Analysis Branch
Division of Systems Safety
Office of Nuclear Reactor Regulation

SAFETY EVALUATION REPORT
ON
ECCS EVALUATION MODEL
FOR
WESTINGHOUSE TWO-LOOP PLANTS

November 1977

SAFETY EVALUATION SUPPORTING CONTINUED SAFE OPERATION
OF WESTINGHOUSE DESIGNED TWO LOOP PLANTS.....

Figure 4

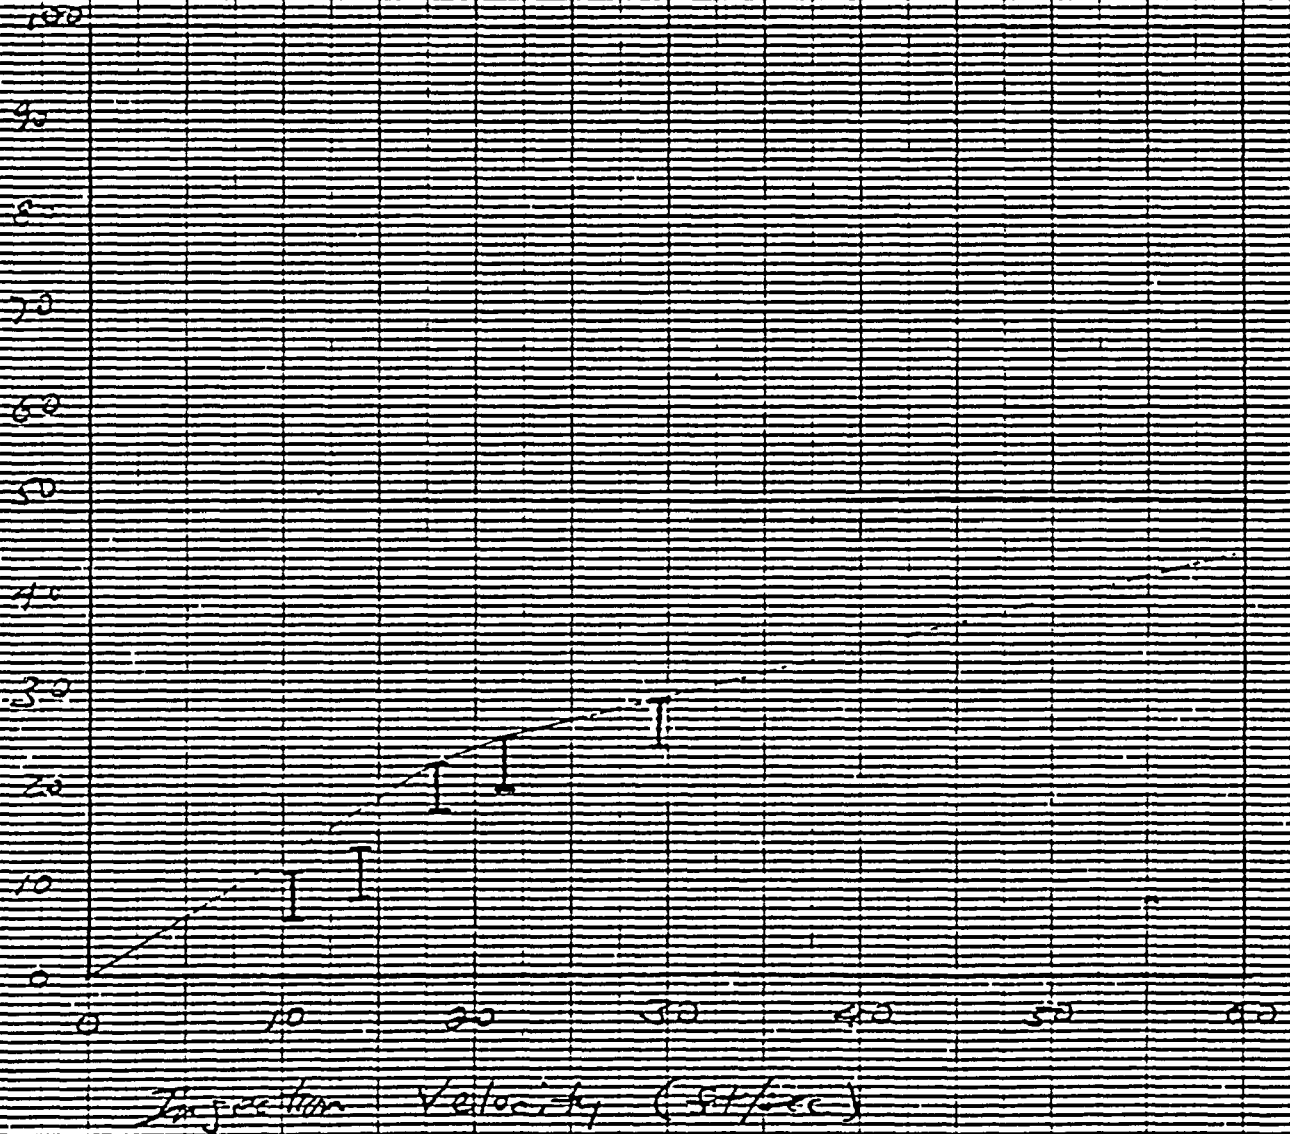
The results indicate that a substantial fraction of the upper plenum has water delivered to it. Figure 4 summarizes the results of all five tests by presenting the estimated percentage of the full upper plenum receiving water from one injection nozzle vs. injection velocity. The estimates of the percentage of the upper plenum receiving water is somewhat complicated by changes in free area (i.e., area outside the guide tubes and support columns) at different locations in the upper plenum. Upper and lower bounds on the results are shown on Figure 4 to account for this effect. An upper bound has been drawn on Figure 4 to indicate the trend with increasing injection velocity and to extrapolate the data to the range of values of injection velocities for the two-loop plants. On the basis of the available experimental and analytical information, we believe that a reasonable upper bound for an upper plenum injection flow distribution for two-loop plants is a uniform delivery to 50% of the upper plenum from one injection nozzle. This distribution will be used for each of the two injection nozzles in Section V of this report in which the overall effect of upper plenum injection is assessed. Also, this provides the basis for our conclusion that UPI will not reach the upper core region as a narrow jet of liquid.

Our model assumes that the upper plenum injection flow from each injection nozzle is uniformly distributed to one half of the upper plenum and therefore to one-half of the core. This is based on the KWU data described above and depicted in Figure 4. Based on the staff model the worst case has been determined to be injected from both nozzles covering the whole core. Although the data indicate that the assumption that one-half of the core is covered by injection water from a single nozzle is slightly conservative, an additional conservatism exists in that the distribution of water from the two injection nozzles is assumed to be uniform over the entire core. The data indicate that more water is delivered in the center of the region covered by the water and that the amount near the upper plenum periphery is significantly less. A nonuniform delivery of upper plenum injection water in the model could be advantageous in reducing the amount of entrainment into the steam generator. In order to modify the assumption of uniform delivery to one-half of the core from each injection nozzle, additional experimental data on a two-loop upper plenum geometry would be required or a model based on the physical phenomena (i.e., not empirical) which could bound the KWU data would be required.

Figure 5

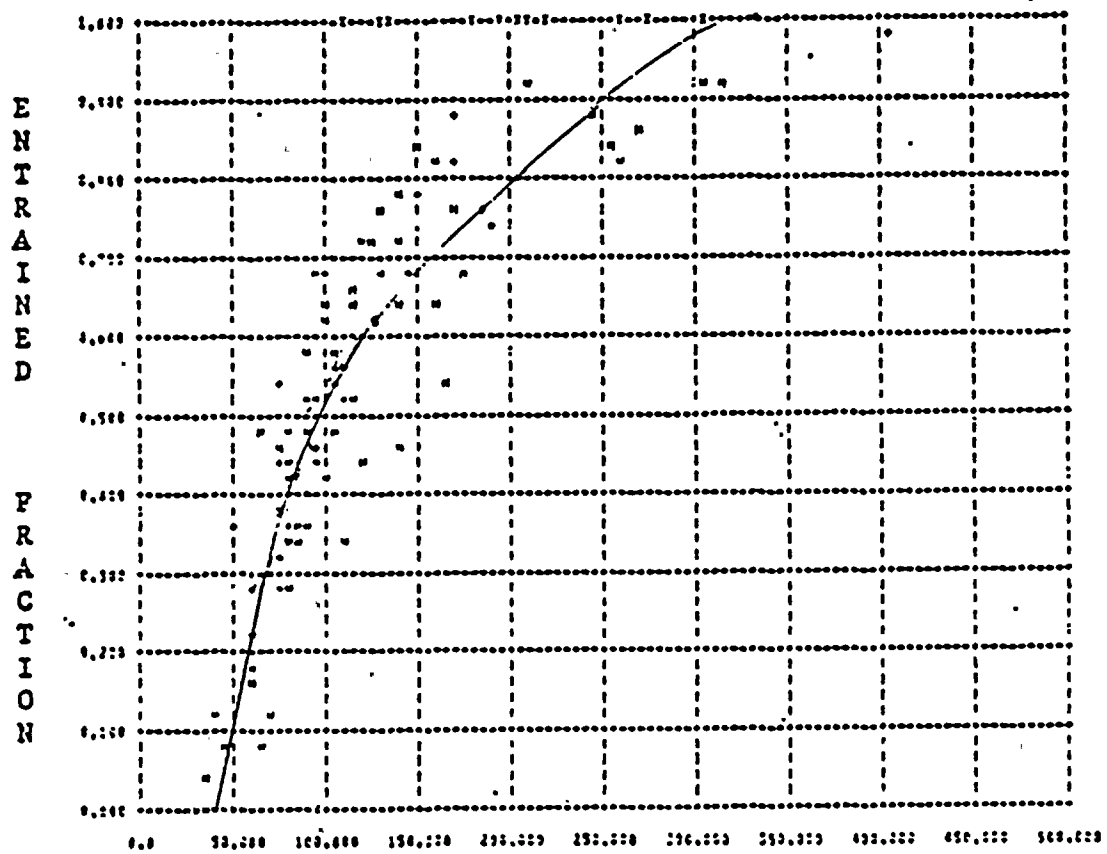
Entrainment increases rapidly as the gas velocities are increased above the critical velocity for the onset of entrainment. This trend is seen in all of the data. A linear fit to the data on Figure 5 was used for entrainment fractions up to .3.

The model used by the staff to account for entrainment caused by vaporization of upper plenum injection water is based on the Ross work described in Section III of this report. The onset of entrainment is calculated to occur at a modified momentum flux of $40(\text{lb}/\text{ft}\cdot\text{sec}^2)$

Figure 10

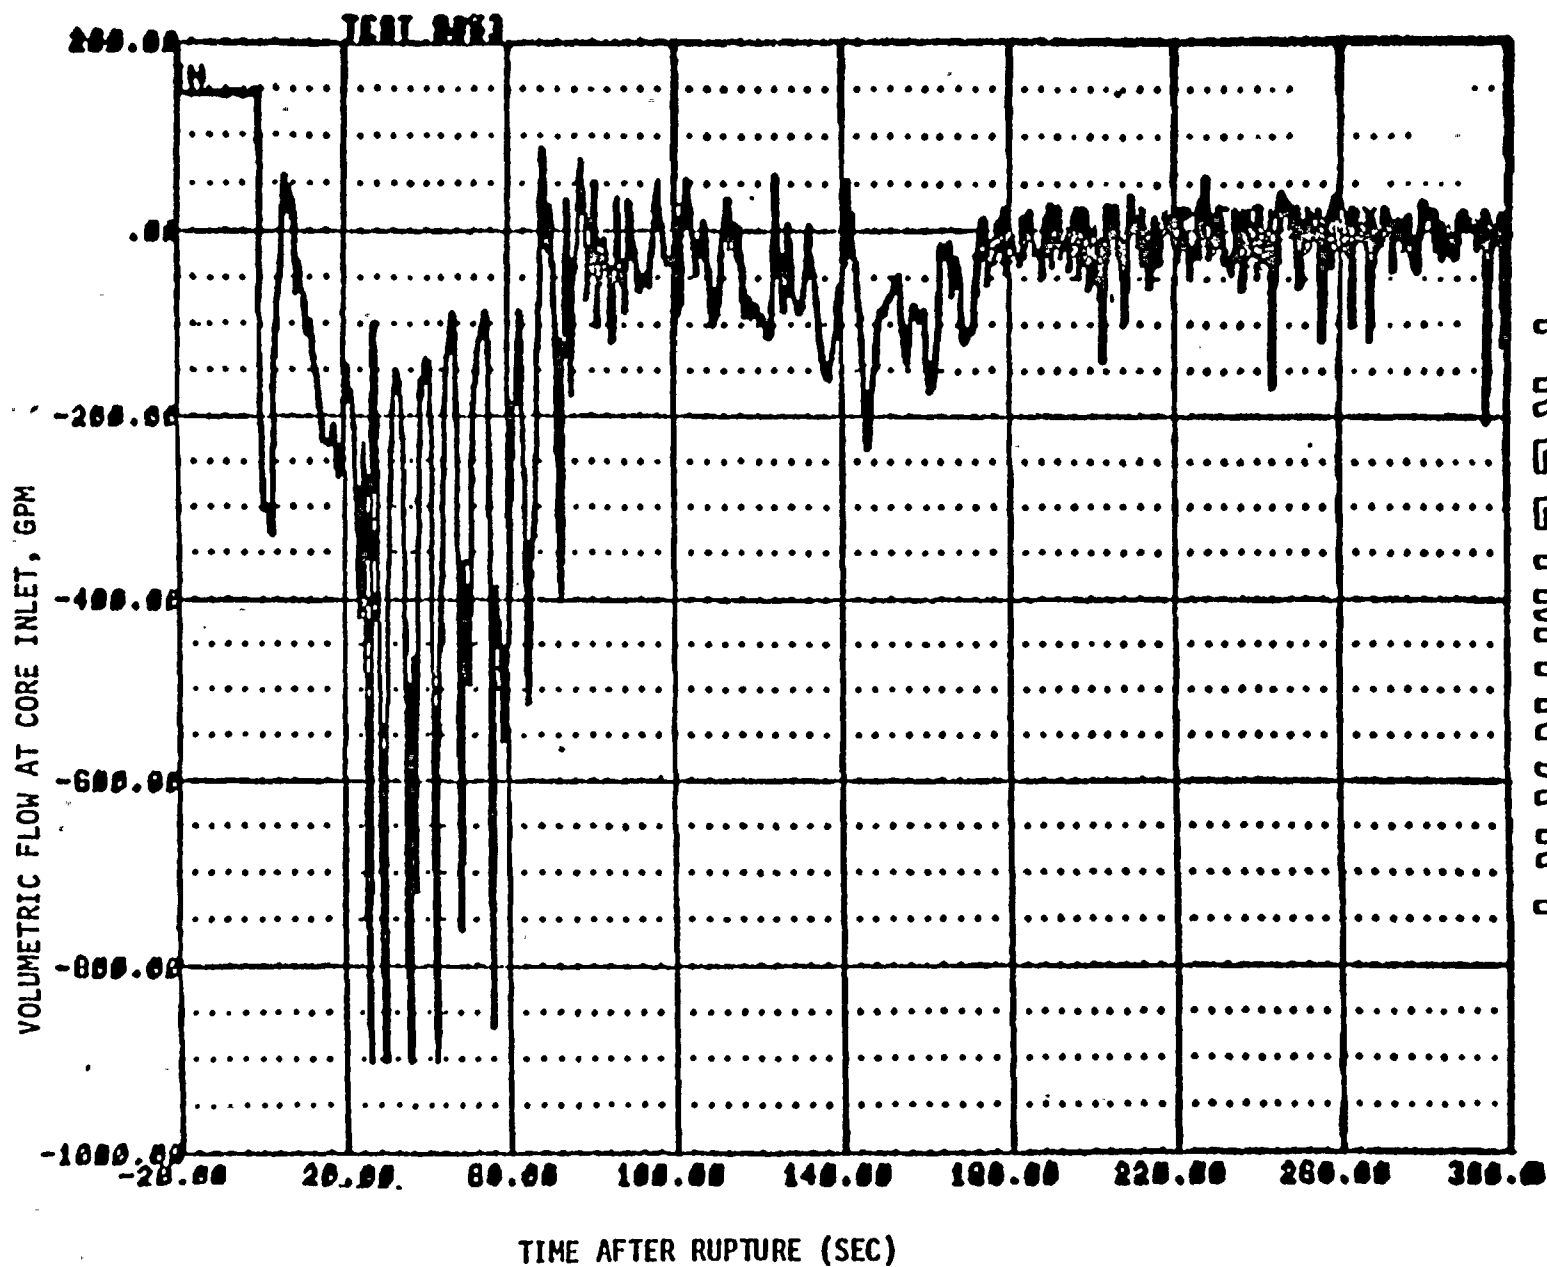
increase from 10 lb/ft^3 and a continuing trend of increasing density thereafter. The general trend of poor bottom reflooding persists throughout each semiscale test. This is also shown in Figure 10 which illustrates the volumetric flow rate at the core inlet. This figure clearly indicates negative flow at the core inlet until the end of UPI at which time the volumetric flow rate oscillates around zero.
